**SUNDRY NOTICES AND REPORTS ON WELLS**

*THOMBSH FEDERAL #1*

THORNBUSH FEDERAL #1  
 PROPOSED STATUS  
 SE/4 SEC 1, T-18-S, R-31-E  
 EDDY COUNTY, NEW MEXICO  
 NM-2538

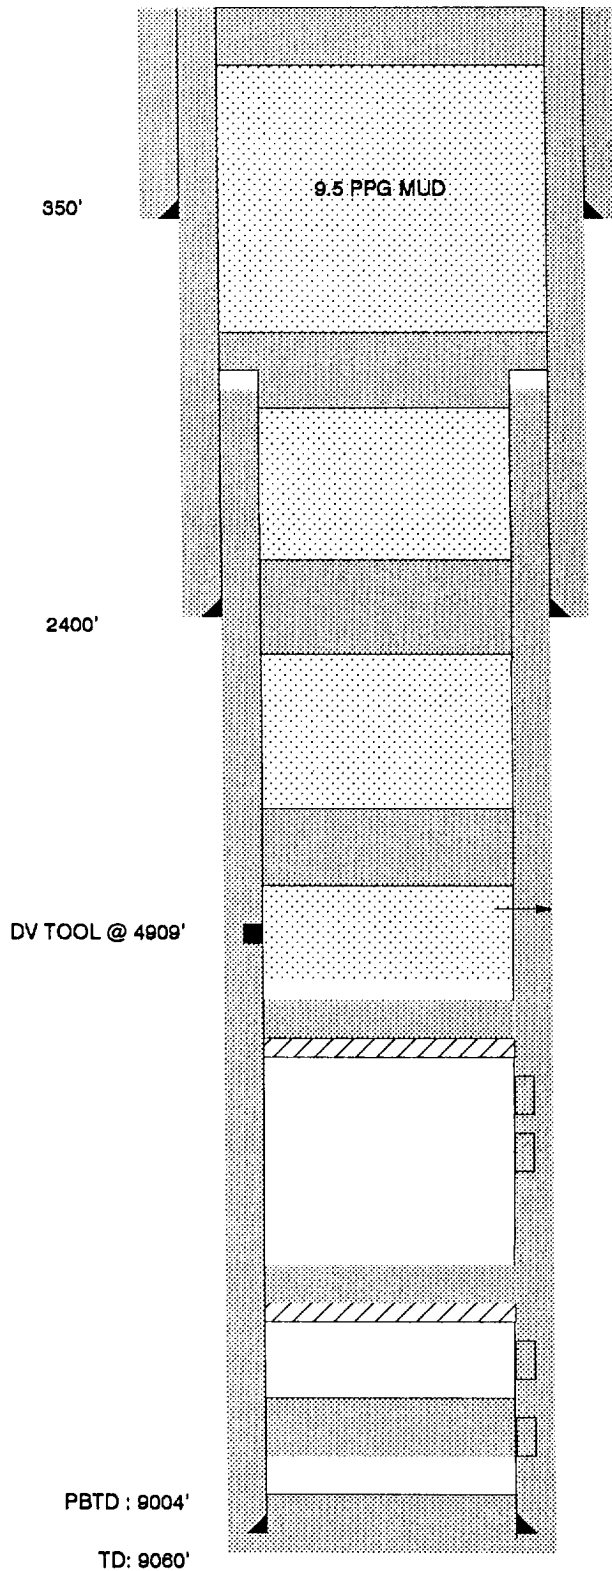
*See attached. Also tag plug @ 4500' & spot 100' plug @ 300' - 400'.*
